From: Scala, Mary Joy
Sent: Friday, August 22, 2014 12:37 PM
To: 'Knipp, Jay'
Cc: mrmstynson@gmail.com
Subject: BAR Actions - August 2014 - 427 Park Street

Certificate of Appropriateness Application

BAR 14-08-03
427 Park Street
Tax Parcel 530023000
Price-Poore House, LLC, Owner/ Jay Knipp, Ilex Construction, Applicant
Partial demolition, new rear addition, parking lot

**CITY OF CHARLOTTESVILLE
BOARD OF ARCHITECTURAL REVIEW
STAFF REPORT
August 19, 2014**

427 PARK STREET SITE PLAN AMENDMENT
 SITE PLAN

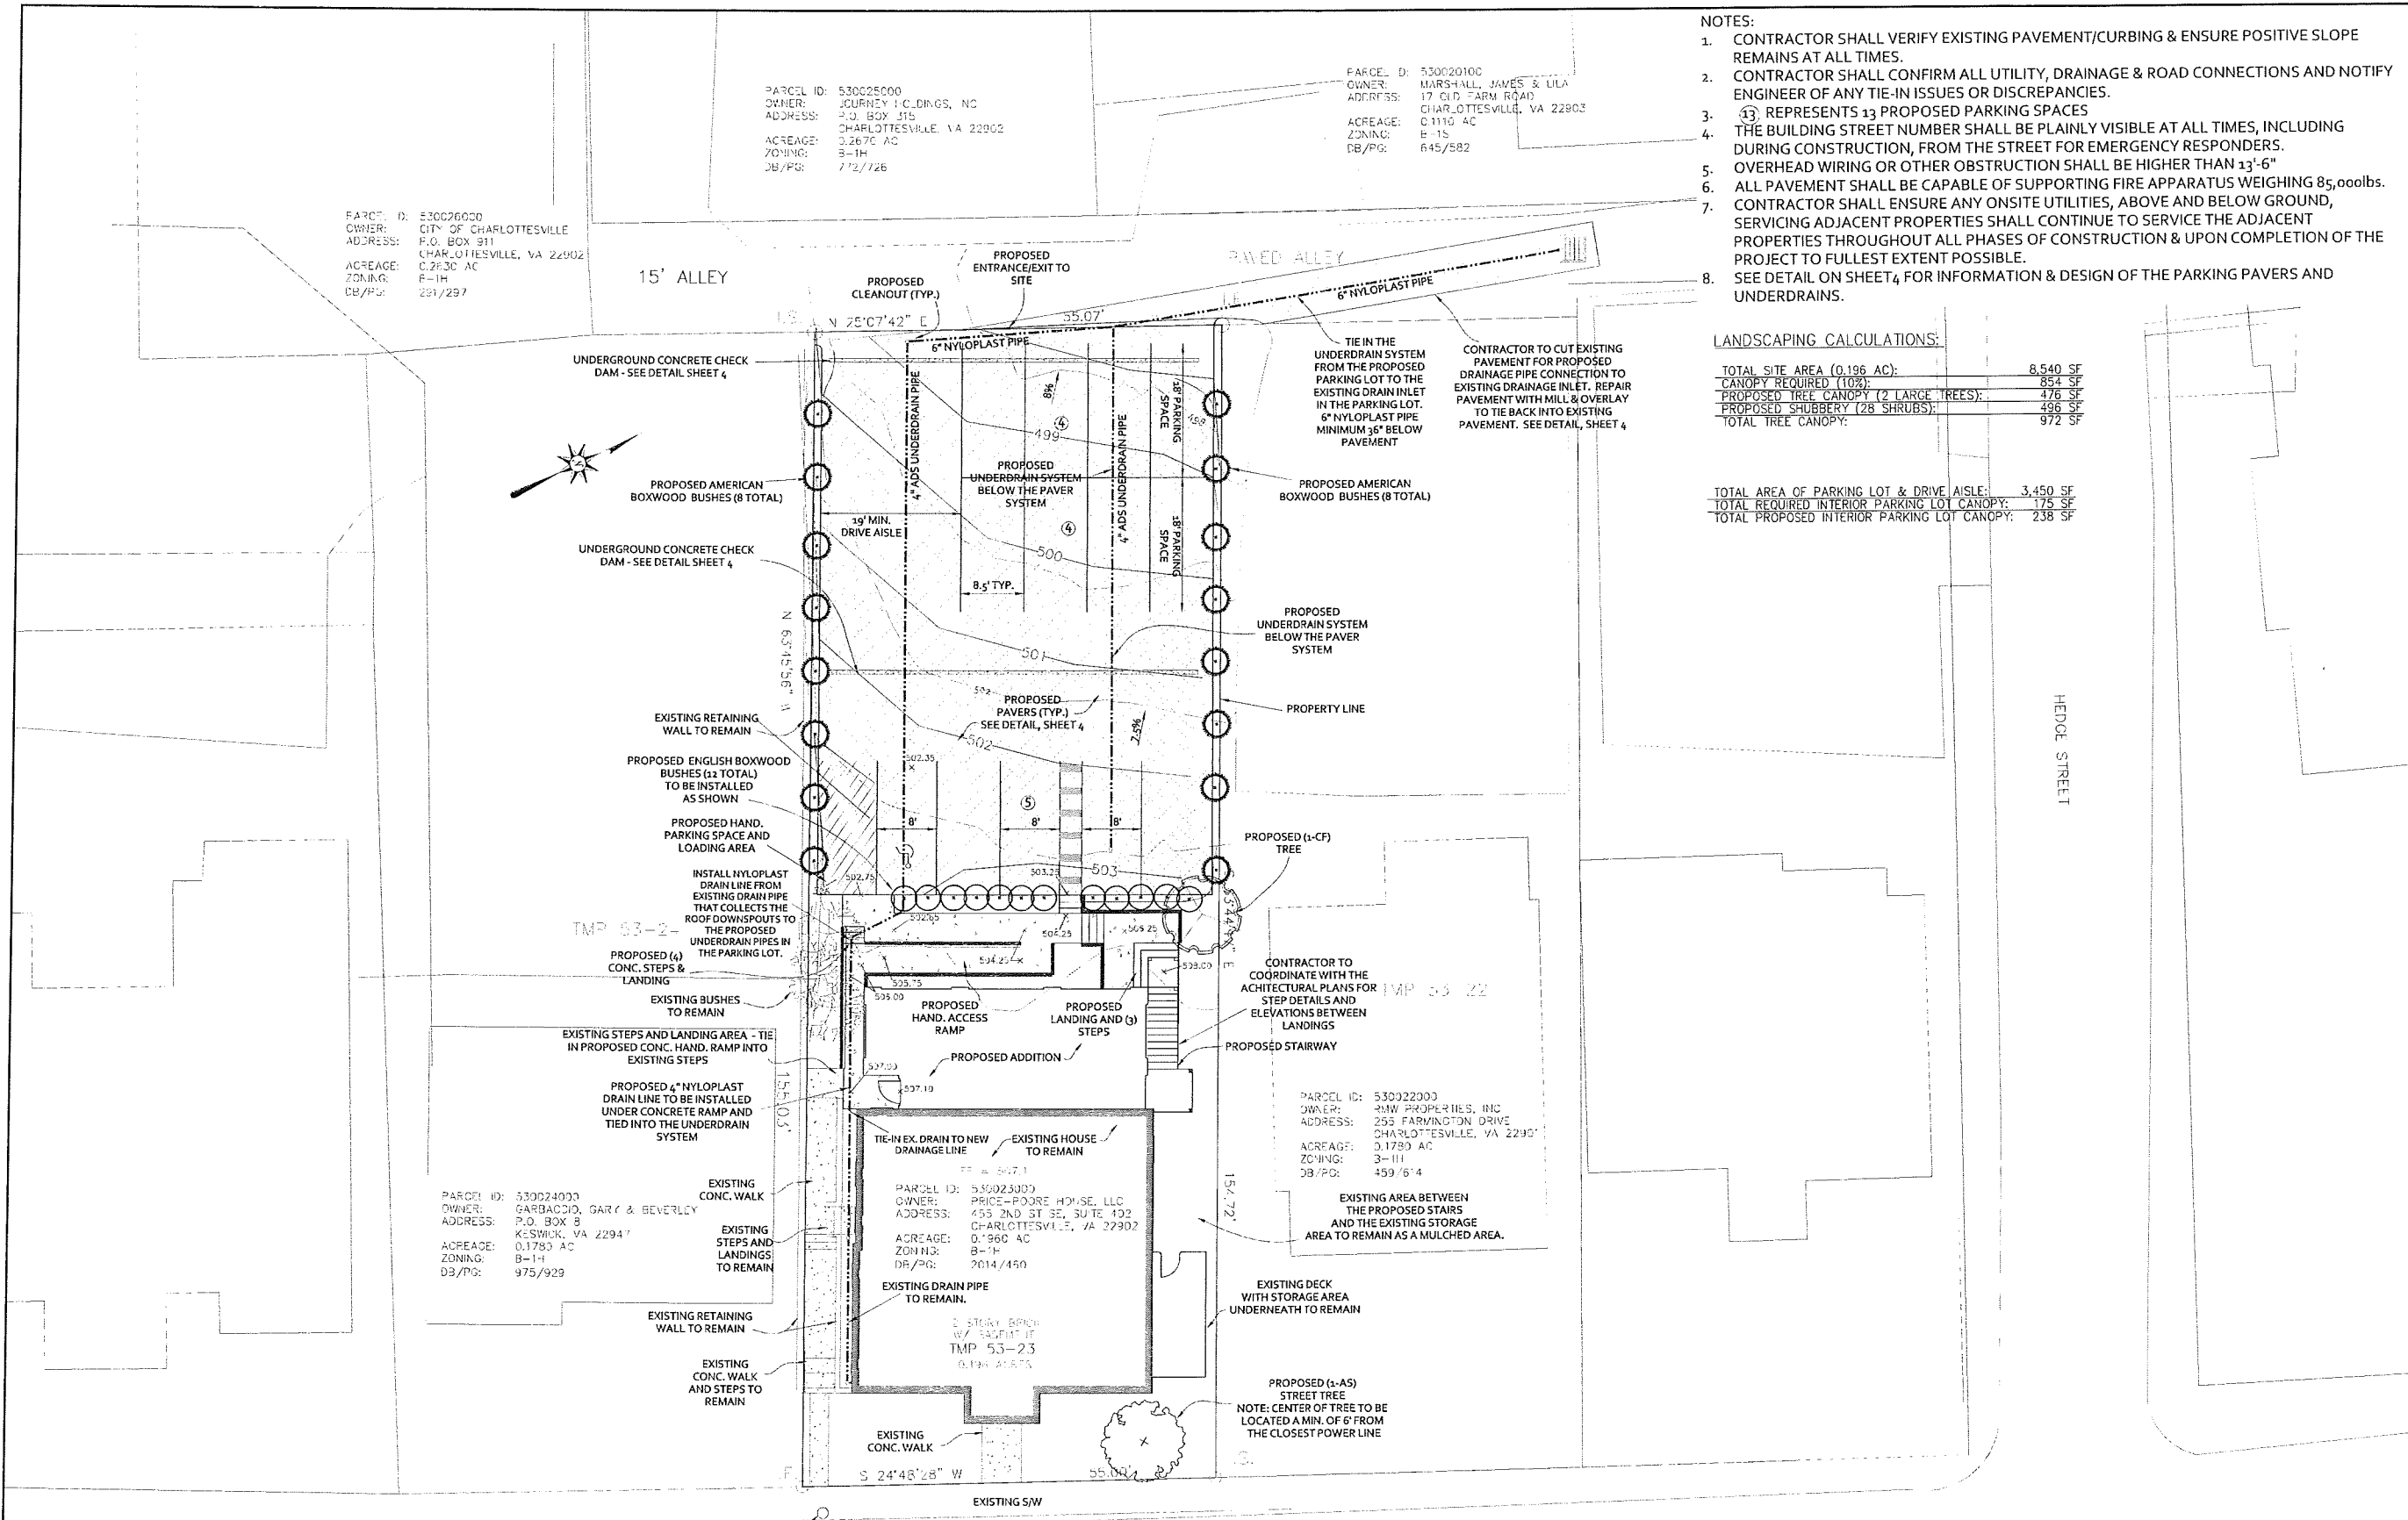
The BAR encouraged the applicant to provide less parking, save more trees, and narrow the entrance to parking. They suggested an ornamental tree for the front yard.

Sec 34-972(a)(5) allows the traffic engineer to consider a smaller width entrance with BAR's recommendation. You might want to pursue that.

The parking lot requires a site plan review in addition to BAR review. The BAR should comment on the proposed landscaping, particularly the one new Sweetgum in the front yard.
